From: Fongs Property < >
Sent: Wednesday, January 22, 2025 11:51 AM
To: William Shu Tai WONG/PLAND <wst Wong@pland.gov.hk>
Subject: 回覆: MUP/211 (2)

Run-in/Run-Out Proposal
for vehicular access

項目
DD46 Lot 815 & 816 S.B RP
擬議臨時物流中心
(為期三年)

Ref : TPB_A/NE-MUP/211

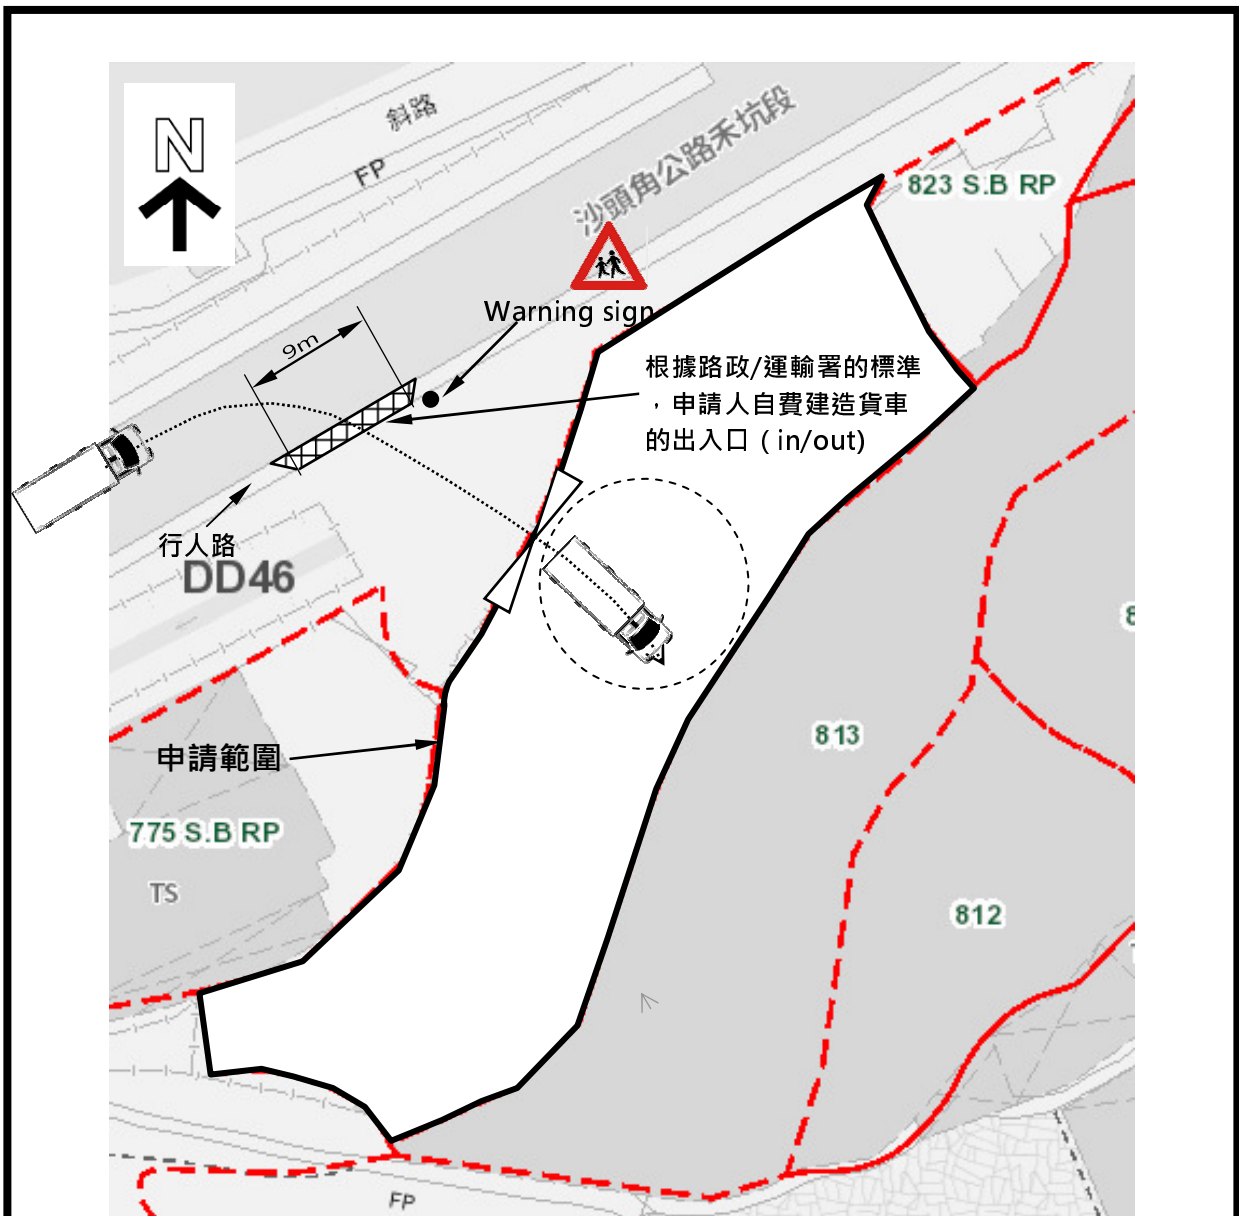
1. There is no proper vehicular access to/from the development to join/leave the linked public road. The details of run-in/out design is missing in the FI, and the run-in/out arrangement should be illustrated on the layout plan.

2. The run-in/out design shall also be subject to HyD's comment and approval.

3. The applicant shall undertake that it should be at his cost employ a competent professional to construct the run-in/out of the vehicular access, and the details of the works shall comply with current TD and Highways Department Standards.

申請人根據運輸署的意見重新規劃有關車路入口的設計，請參閱(run in/ run out proposal for vehicle access)

有關計劃完全根據路政署 / 運輸署標準設計的，申請人在施工時會記錄有關建造過程，並在完工後提供給路政署 / 運輸署批核。

申請人完全明白有關的路口重置計劃非常專業，並會自費聘請專業人士作指導及監督整個建造過程並作紀錄，確保完全符合運輸署 / 路政署的標準。
